STATE OF NORTH CAROLINA  
DEPARTMENT OF TRANSPORTATION

August 31, 2020

Subject: **Revised Modification Request for Section 404 Individual Permit, Section 401 Water Quality Certification and Neuse Riparian Buffer Authorization** for Interstate 40 Widening and Improvements from I-440/US 64 (Exit 301) to just north of SR 1525 (Cornwallis Road), including improvements to NC 42 and SR 1010 (Cleveland Road) in Wake and Johnston Counties, Federal Aid Project No. IMNHF-040-4(139)301; TIP Numbers I-5111 and I-4739, Division 5. Debit \$570 from WBS Element 42346.3.1.

PERMIT DRAWING  
SHEET 92 OF 125

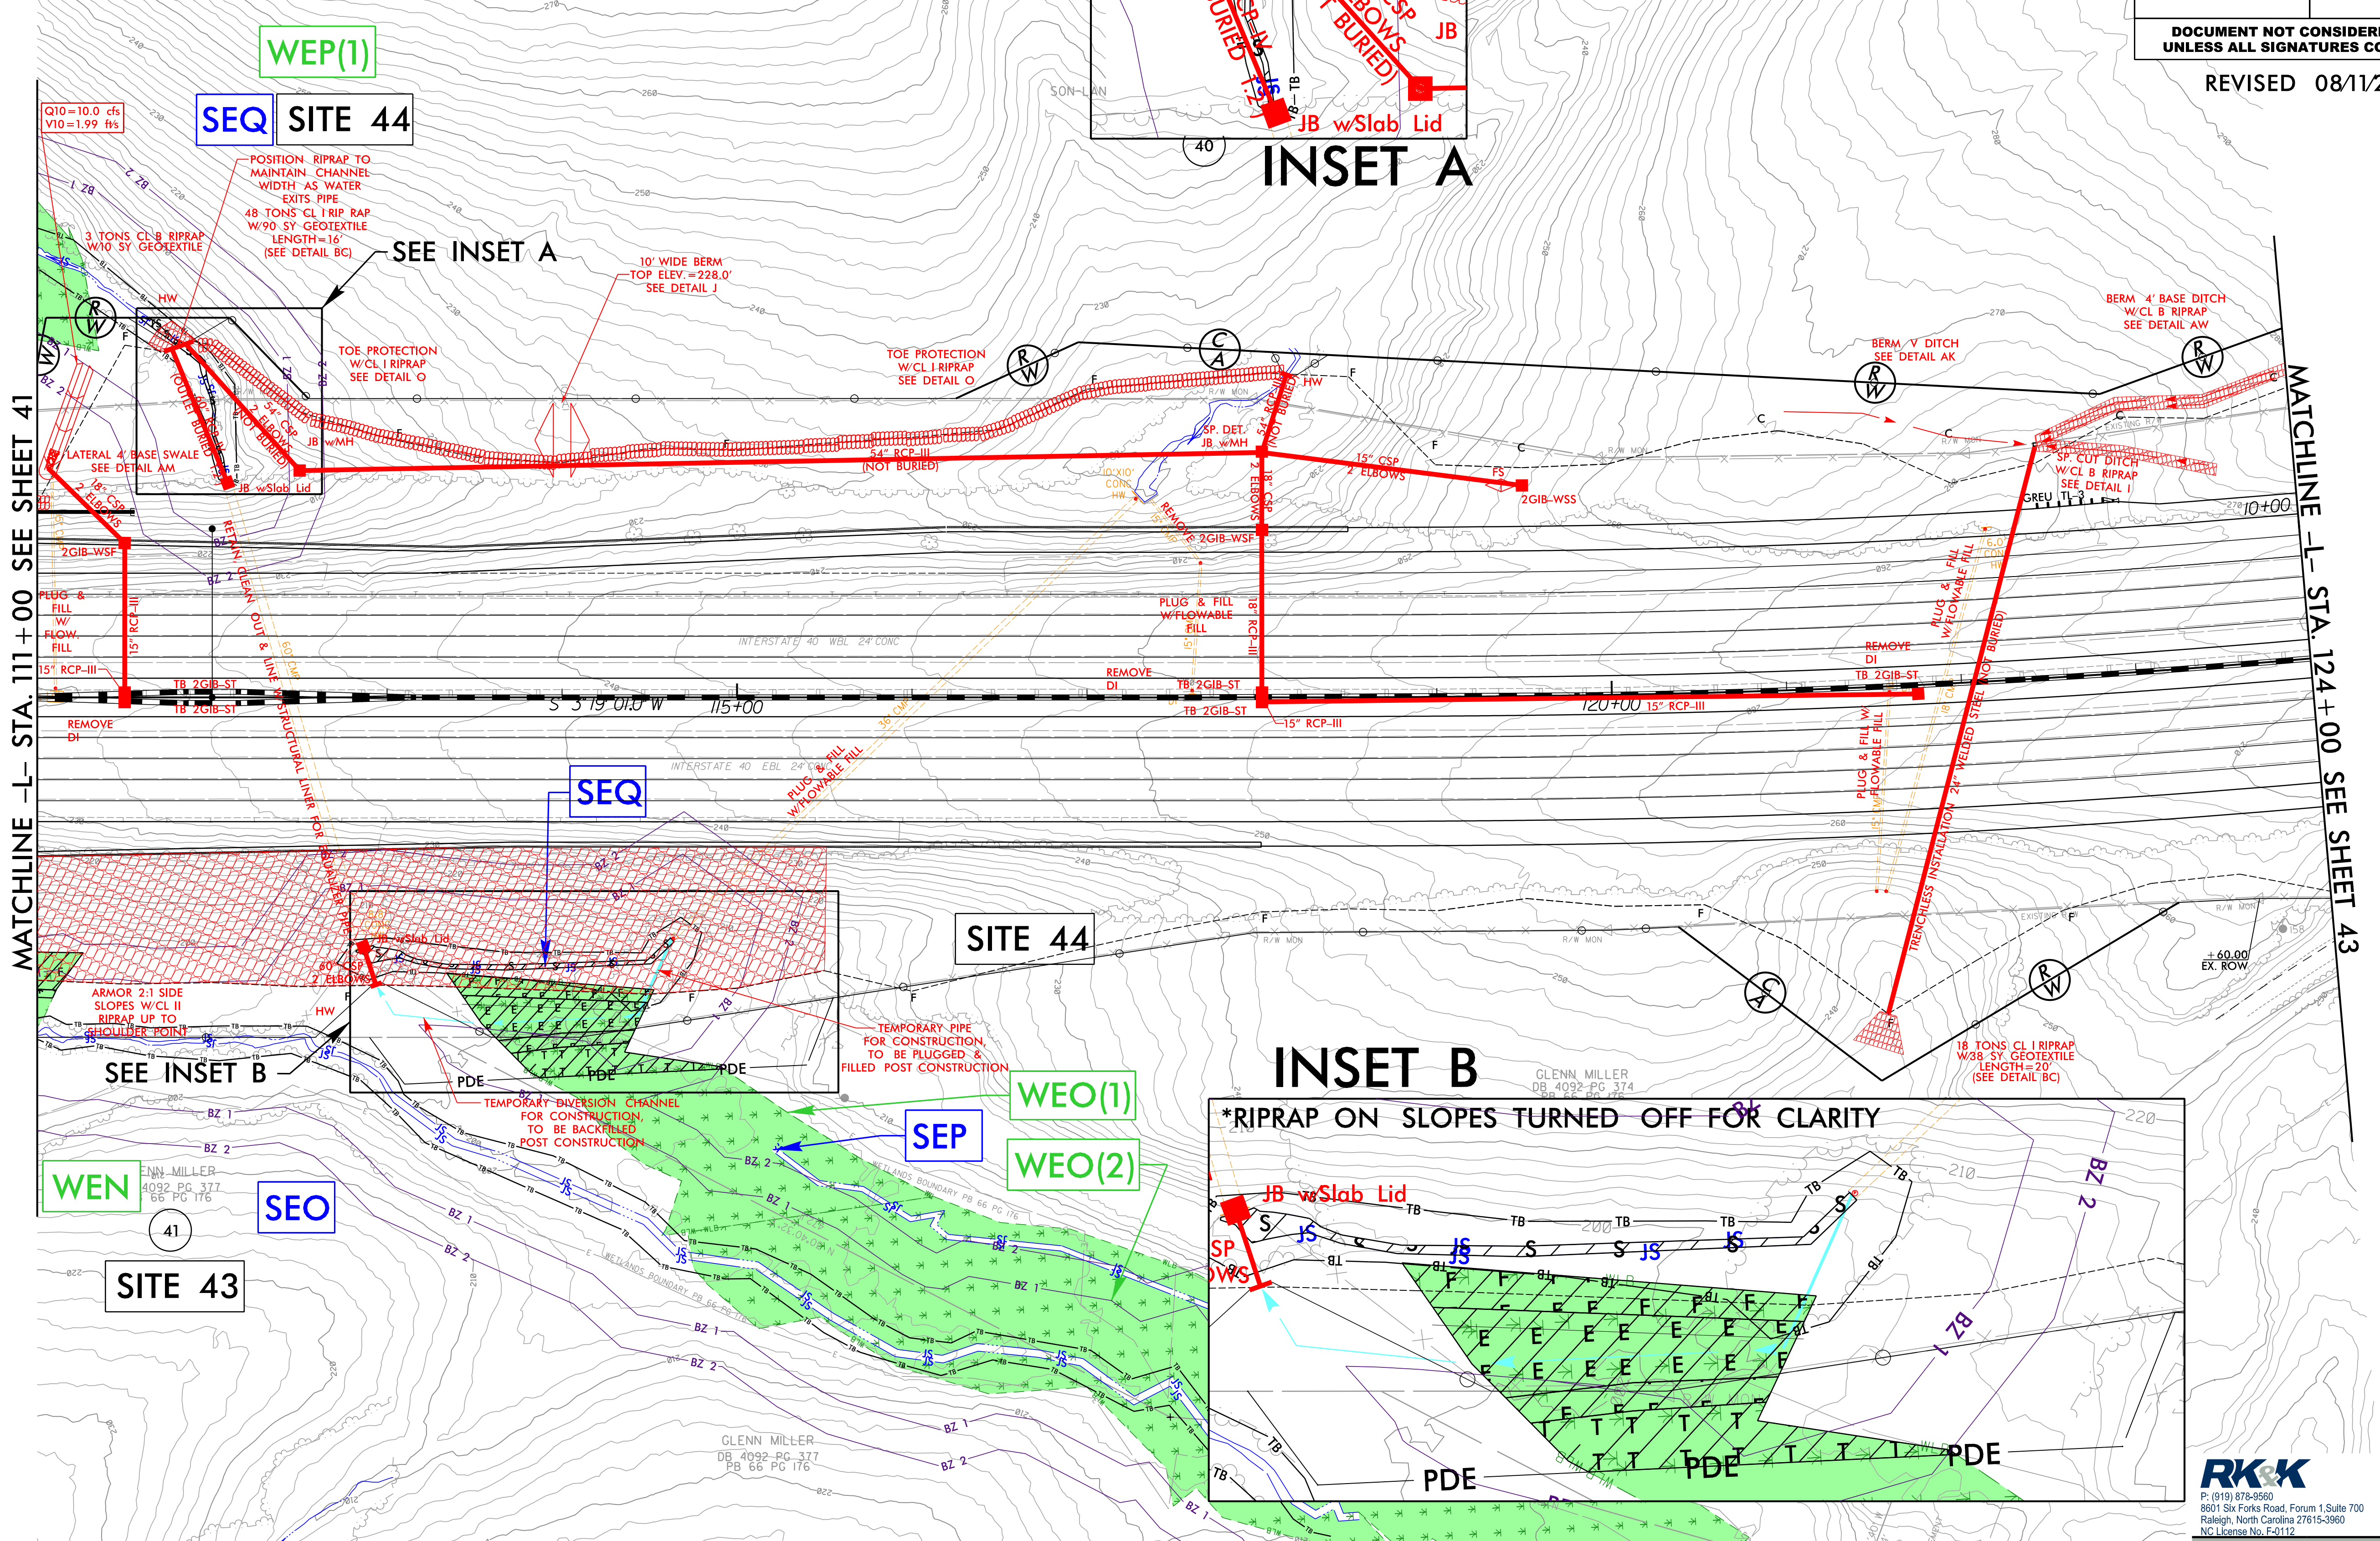
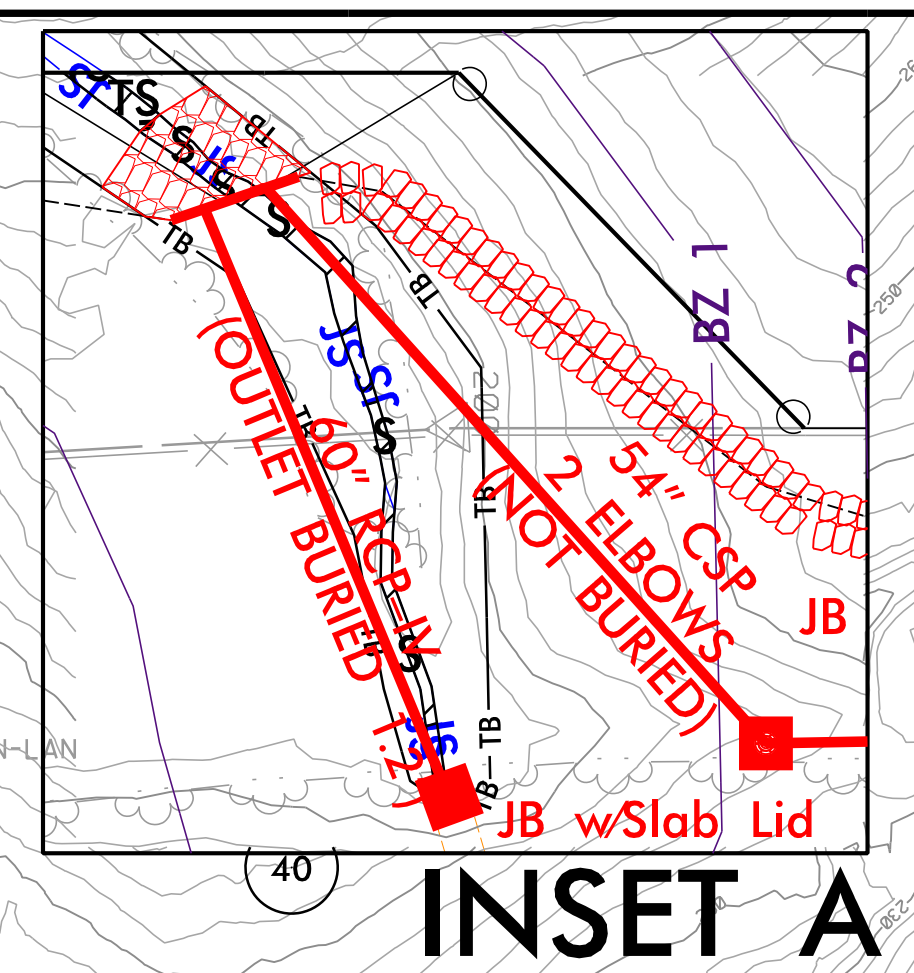
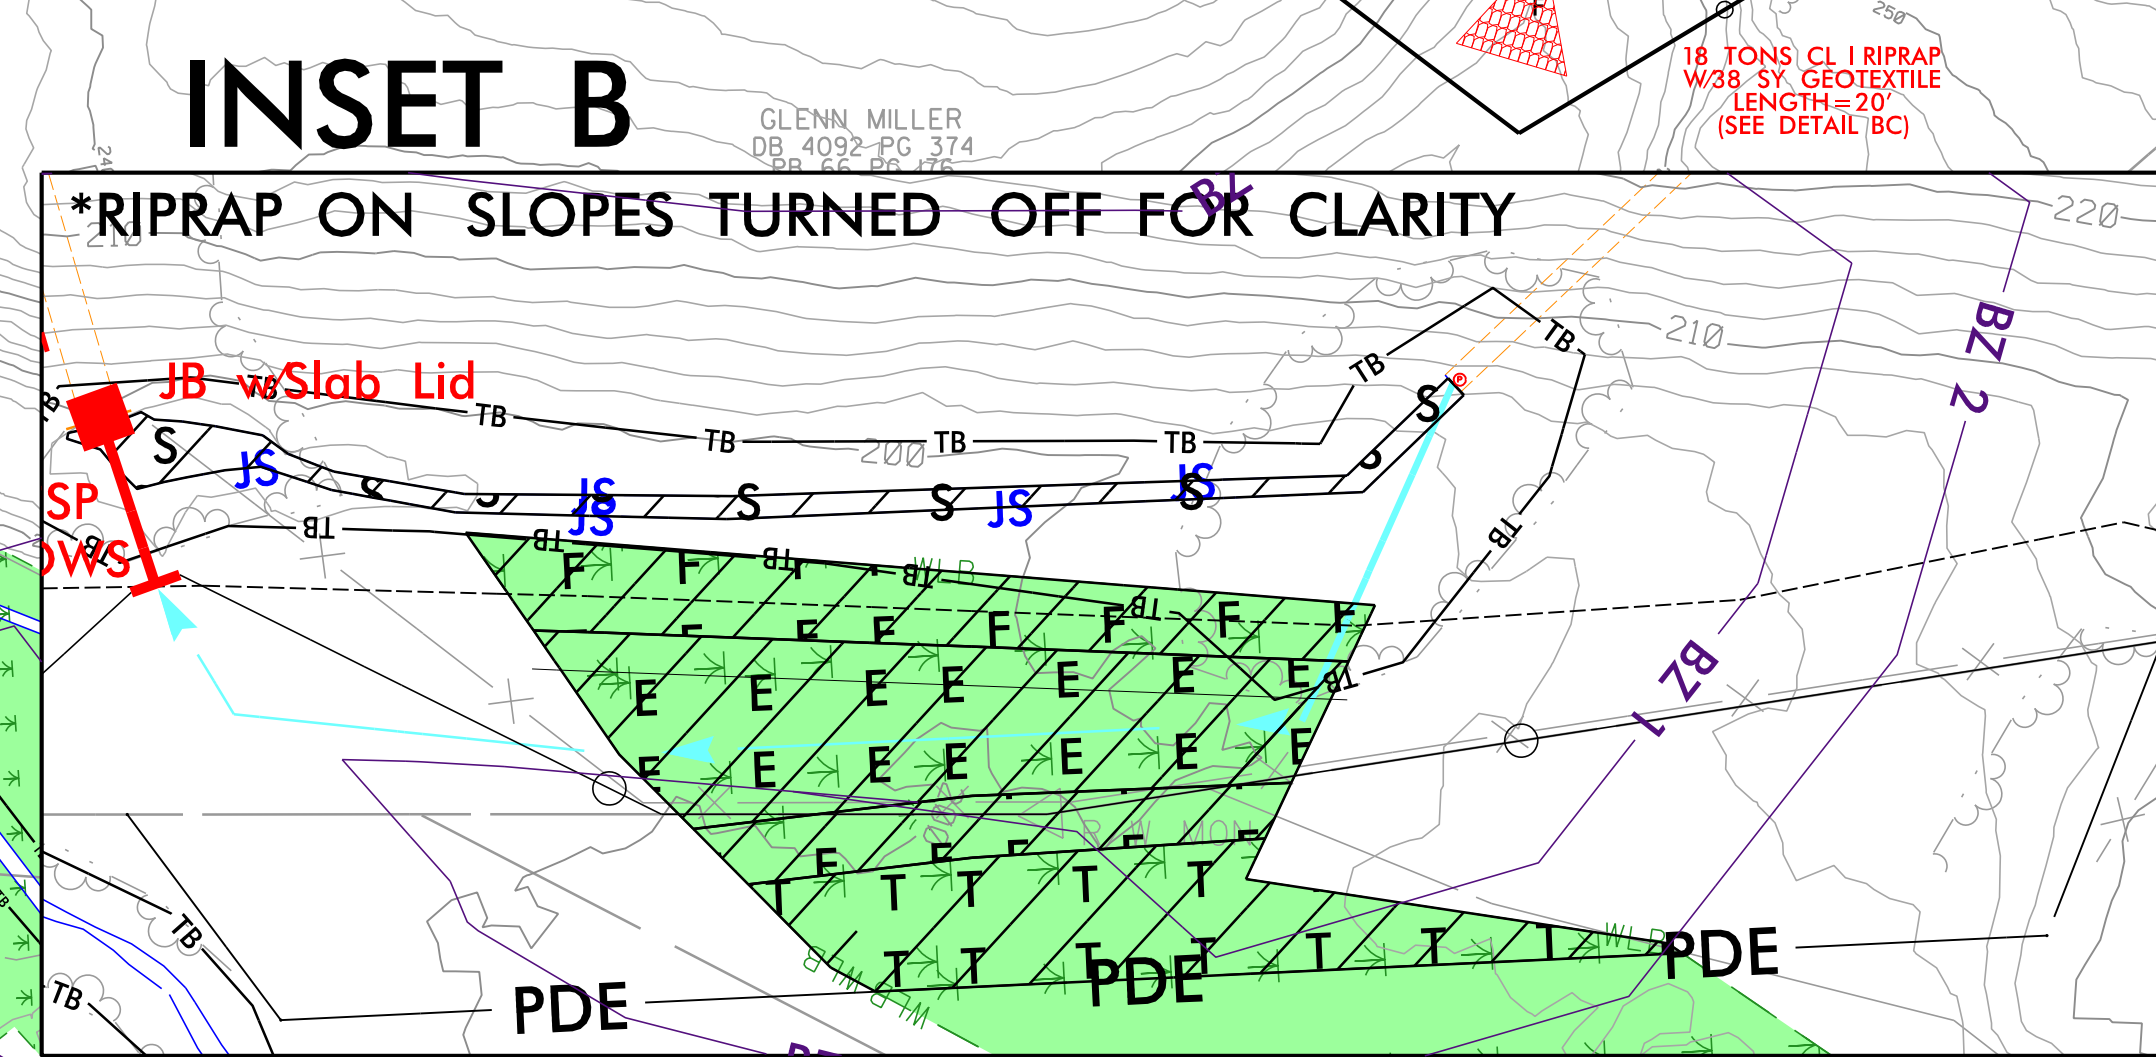
A field revision is being requested at Site 44. Currently, stream SEQ is piped from the east side of I-40 to the west side, travels along the west side of I-40 for approximately 80 feet, then is piped back to the east side. The original design kept this drainage pattern by boring a new 54" steel pipe to the west side of I-40 and then extending the existing 60" pipe to convey SEQ back to the east side. The new design proposes to install a 54" pipe along the east side of I-40 that outlets to the same 60" pipe, thus eliminating the need to bore a new 54" steel pipe. The 60" pipe will still be extended to convey any drainage from the west side to the east as well as to act as an equalization pipe. For construction sequencing, stream SEQ be placed in the relocation channel, as currently authorized, for approximately 3 months. However, this will be a temporary diversion and shown as temporary excavation in wetlands on Permit Drawing Sheet 124. Once the 54" pipe is installed along the east side of I-40, this channel will be backfilled to preexisting elevations, vegetated, and restored as a wetland.

This modification will result in the following:

- 0.043 ac of permanent wetland excavation becoming temporary
- +765 ft<sup>2</sup> of impacts to Buffer Zone 2 through abandoning the channel

PERMIT DRAWING  
SHEET 93A OF 125

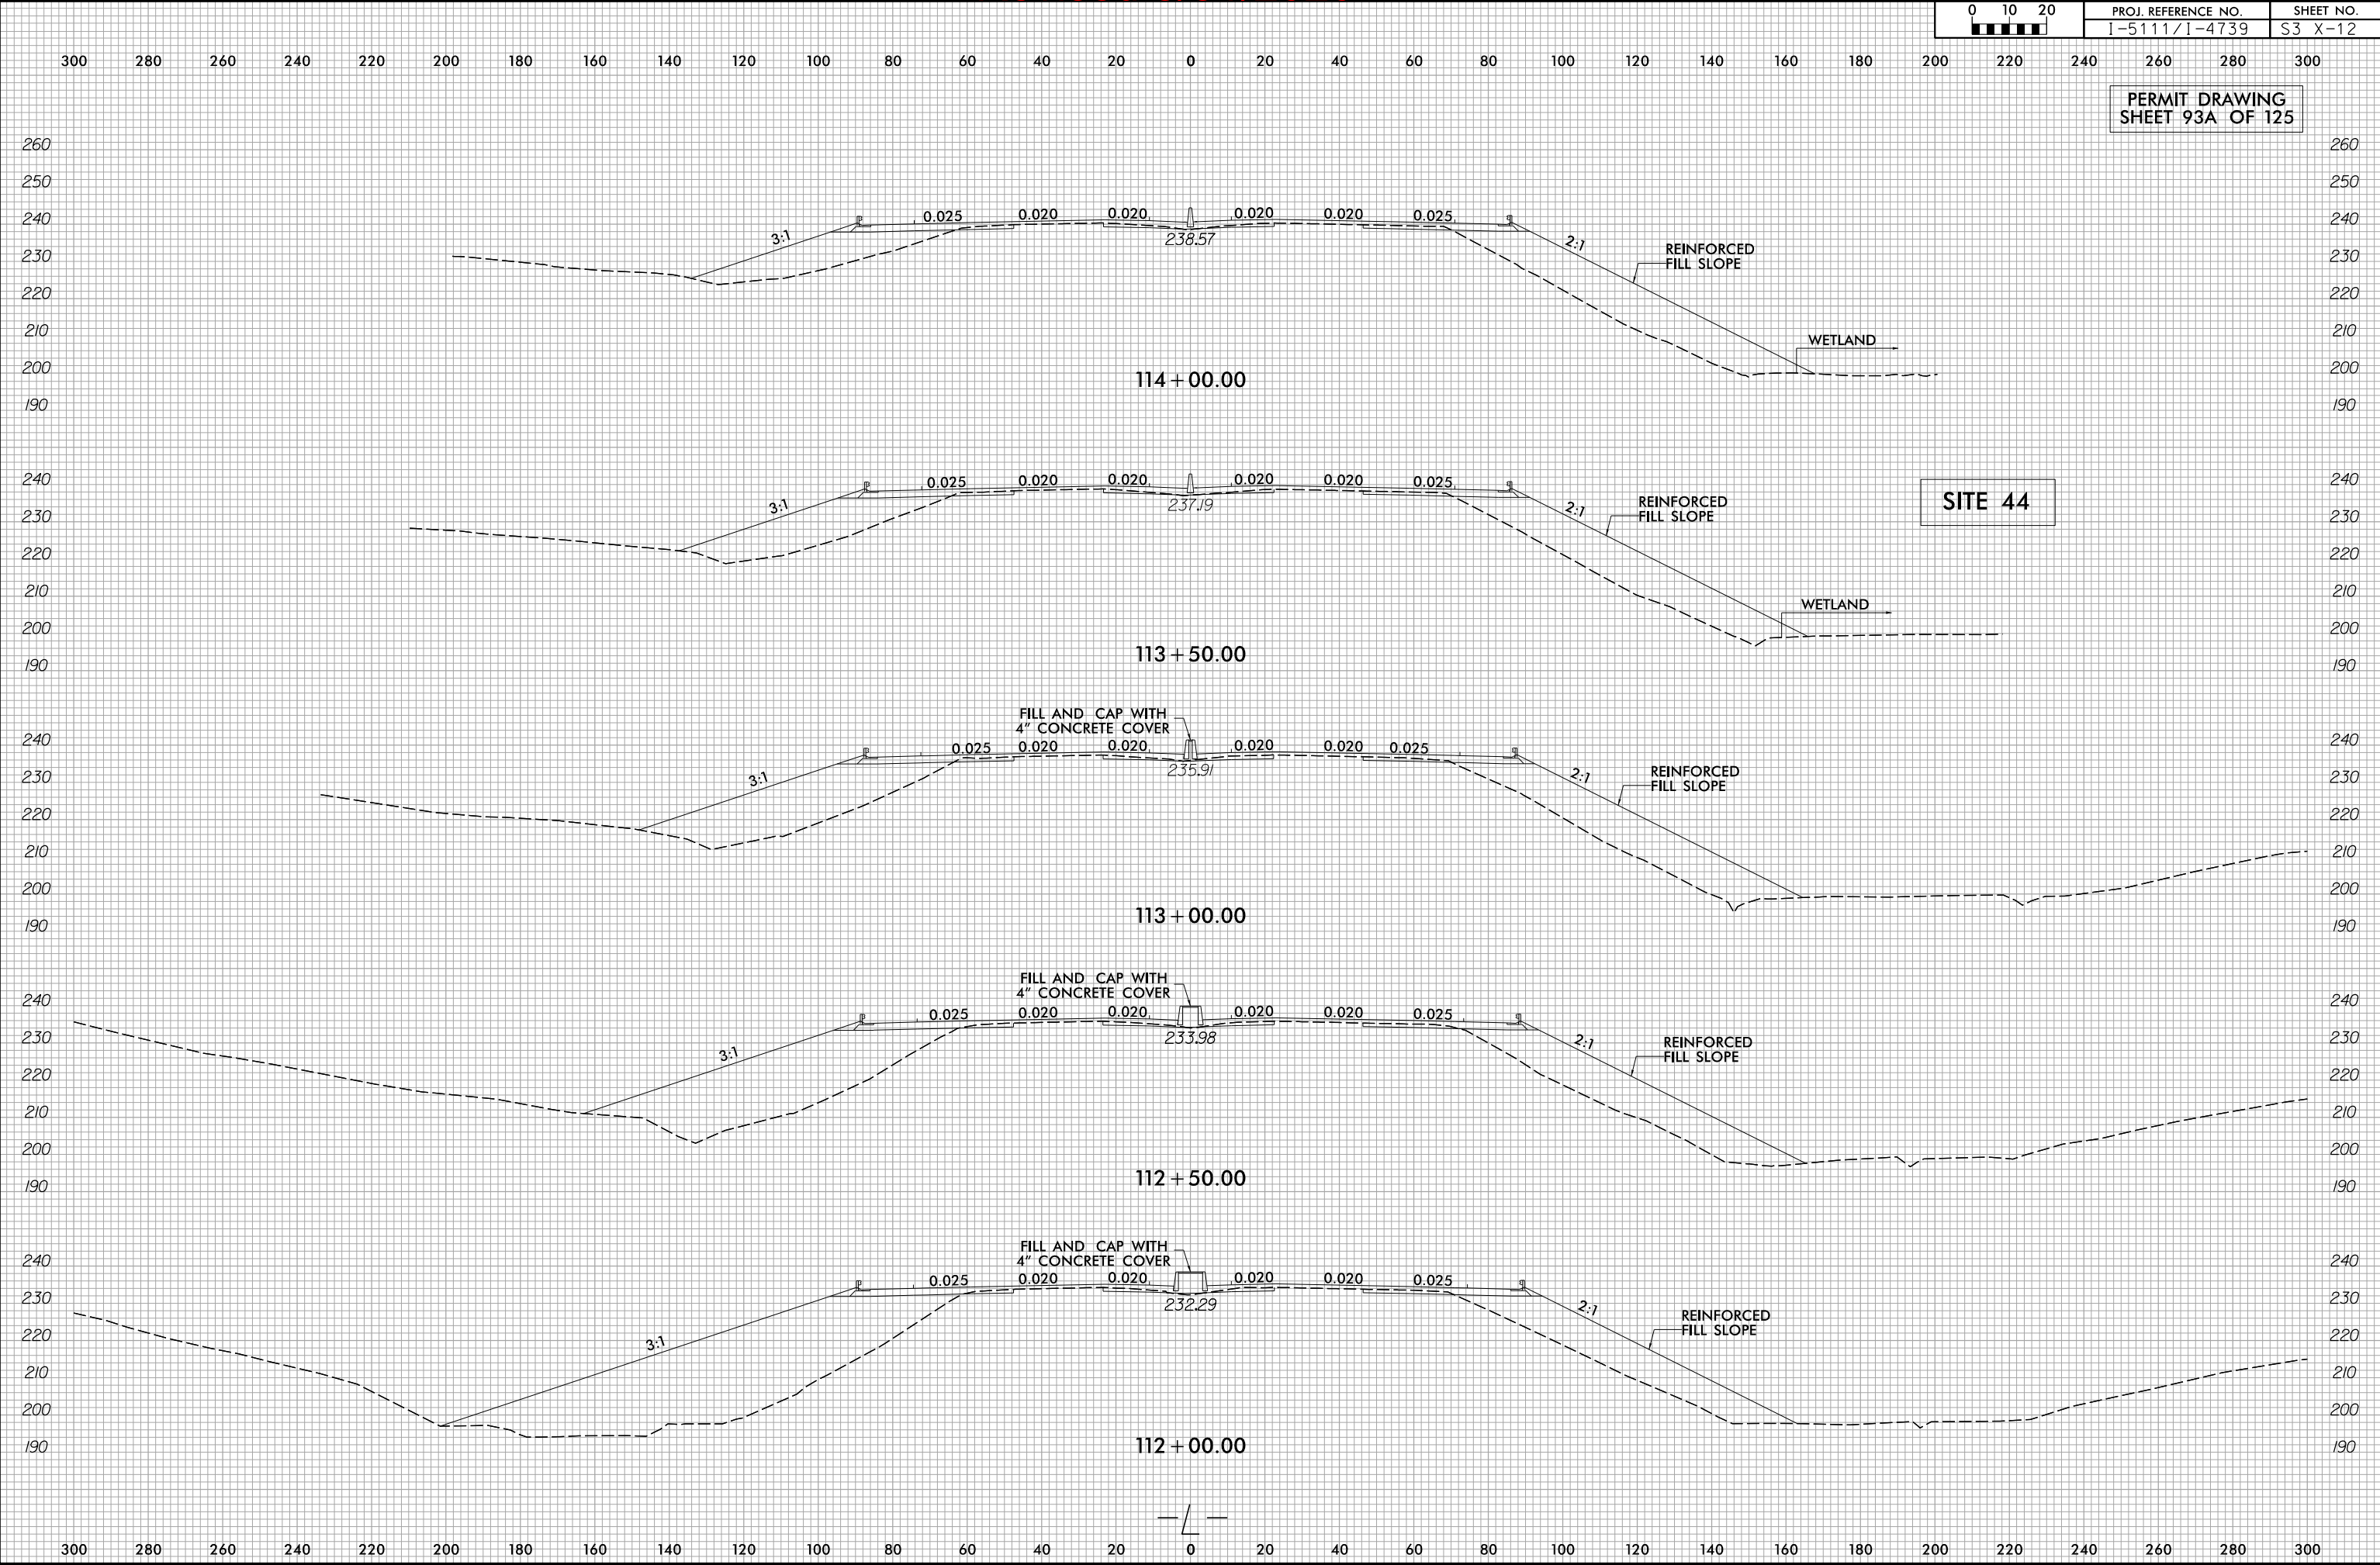
When recalculating the impacts for Site 44, it became apparent that the wetland impacts had been inadvertently under reported in the initial application. These numbers have been corrected on the attached revised impact summary sheets. Permanent wetland fill increases by 0.04 acre to 0.78 acre total. Temporary wetland increases by 0.03 acre to 0.17 acre total. A cross-section of Site 44 (Permit Drawing 93A) is also included as that had been omitted from the initial permit application.
